# Structural Site Visit Assessment Report for Trenton Central High School Trenton, NJ

Final Report – Revision 0

Report Prepared for: New Jersey School Development Authority

Figure 2

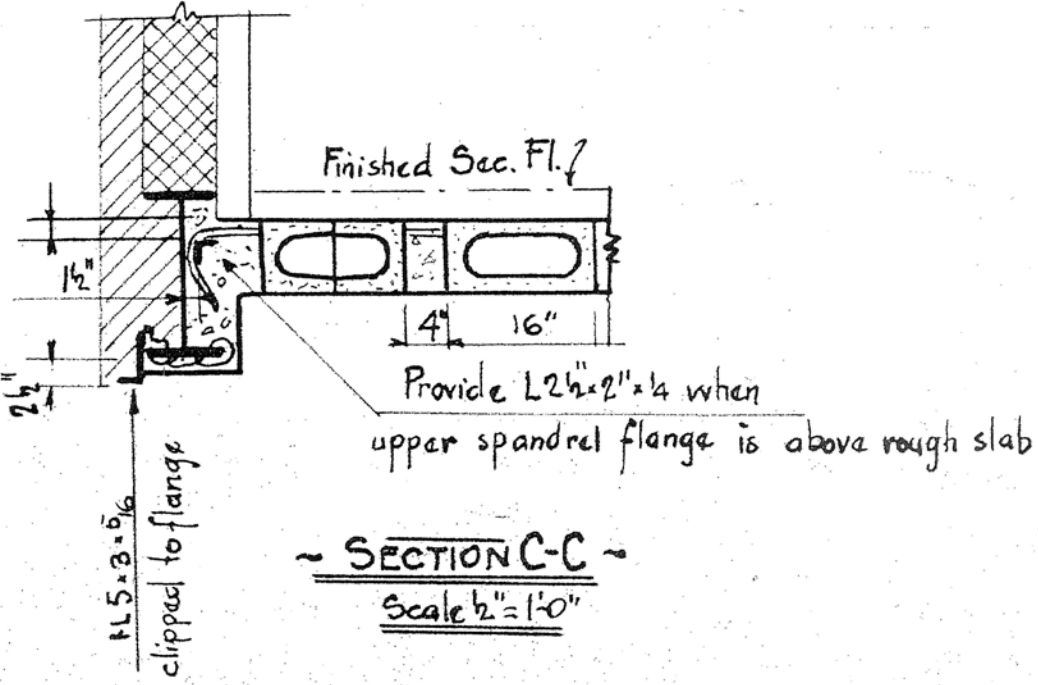
- Deviations from the original design drawings were noted in various places throughout the structure. The original floor system design shown on drawing S-A-3 indicates a masonry/concrete composite floor system (Figure 2); however a concrete pan and joist system was utilized almost exclusively throughout the structure (photographs [4] and [5]). A concern noted with the pan and joist system is the joists do not appear to bear directly on the concrete encased steel beams. It seems likely that reinforcing steel from the floor system may extend over top of the steel beams, which similar to the condition noted previously, is very unlikely to reveal an adequate analysis conclusion for support of dead and live loadings. A few areas utilized a one way slab with beams such as the auditorium floor and adjacent first floor level rooms to the south (photograph [6]), but the original floor system shown on the design drawings was not observed in any place during our site visit. Furthermore, several steel beams shown on the original design drawings were not installed in lieu of the concrete pan and joist system which runs parallel to the direction of the missing steel beams. This deviation from steel beams to concrete is troubling as it again brings into question the validity of the steel beam locations for the entire building.

**Cut Line – Concept A**

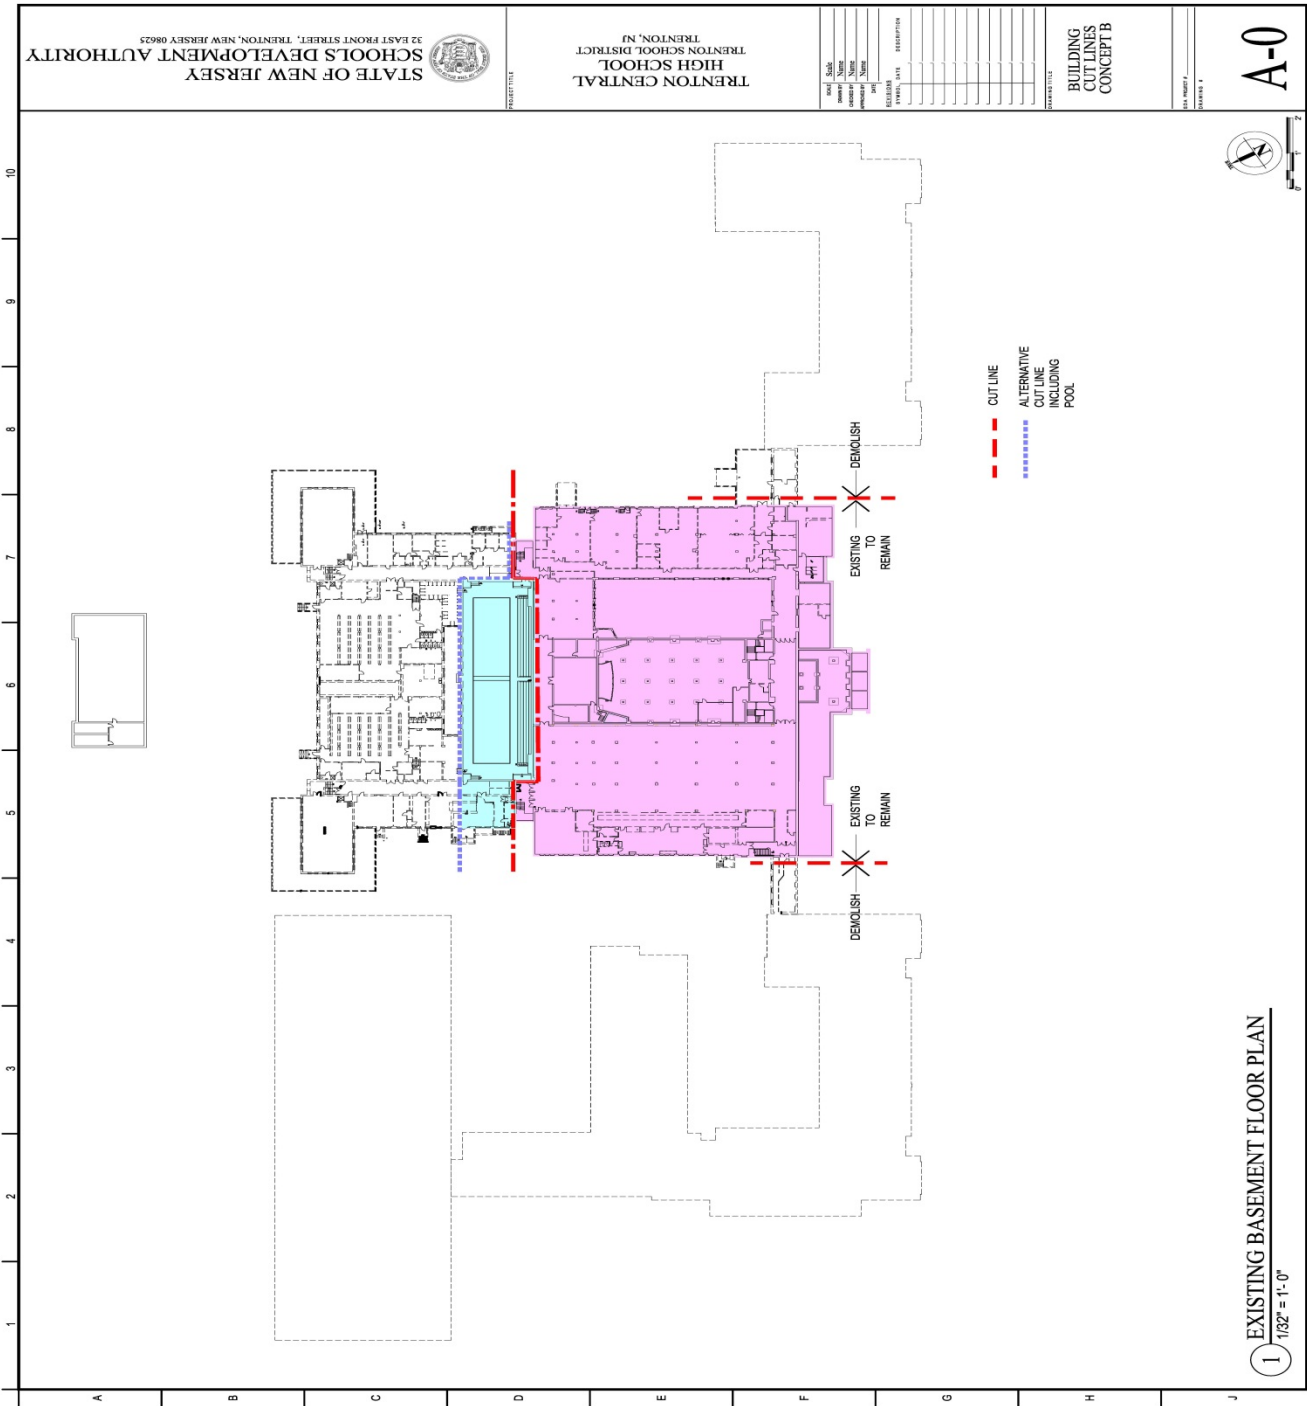
- The cut line to keep the Concept A option would involve cutting directly through two 8” steel beams supporting the vault room located on the first floor immediately adjacent to the main office. These beams would need to be supported through the installation of permanent shoring as well as installation of foundations in the unfinished area below the vault space.

- According to the original design drawings, there are no columns located at the Concept A section option high roof area proposed cut lines along the east side at both the north and south ends. The structural steel beams spanning in the east-west direction supporting adjacent roof framing and walls frame into perpendicular steel beams which connect into columns outside of this high roof area. This presents a very difficult situation for support at this cut line location due to the existing wall foundations below as well as the complexity of installing a new column and cutting of the existing beam. Holes would be cut in both the roof and floors in order to allow installation of the new columns. Additionally, installation of new foundations to support new columns in these areas could very well cause instabilities of the existing wall foundations. Any instabilities in these areas could cause cracking of both the interior finishes and the exterior brick façade.

- The two extensions on either side of the Concept A option adjacent to the stage area on the north and south sides which serve as corridors connecting the auditorium floor to the corridors behind the stage area do not align over the existing column grid lines. The line of support for this floor as well as the exterior wall is supported by beams at the level of the cafeteria roof and is ultimately supported by columns outside of the proposed cut lines for the Concept A option. In order to support the structure at this cut line, new columns would need to be installed, existing beams sheared at these columns, as well as the installation of new foundations to support the columns. The existing structure in these areas would need to be temporarily shored prior to performing all of these retrofits before demolition efforts begin. Additionally water damage was observed in the first floor flooring on the south side at the time of our visit (photograph [16]), most likely due to lack of maintenance for the gutter and downspout system (photograph [17]). We did not access the structure in this area however additional investigation should be conducted if these areas are to remain.

- Demolition of the cafeteria is a concern due to the roof framing bears on the north wall of the auditorium. It is recommended to shore the entire roof framing system of the cafeteria near the auditorium wall and carefully cut the framing north of the shoring point. Once the cut has been made, the remainder of this roof framing should be carefully removed from the auditorium wall. The first concern of this three story wall is the possibility of out of plane movement during demolition could cause partial or total collapse of the auditorium wall that is to remain. Secondly, once the cafeteria roof framing is removed, brick will need to be replaced within the pockets where the roof framing had been in order to prevent local areas of collapse in this wall.

- The fan room roofs located on both the north and south sides of the stage area are not supported along column lines. It is unclear as to whether these rooms are proposed to be kept for the Concept A option; however new columns, connections, and foundations would need to be installed for support of these areas if they are to remain. The same complexity of shoring and installation would exist similar to the previous two bulleted areas. Additionally, risks to the interior finishes and exterior façade exist in this area as well throughout the shoring, installation, and demolition phases of the project.
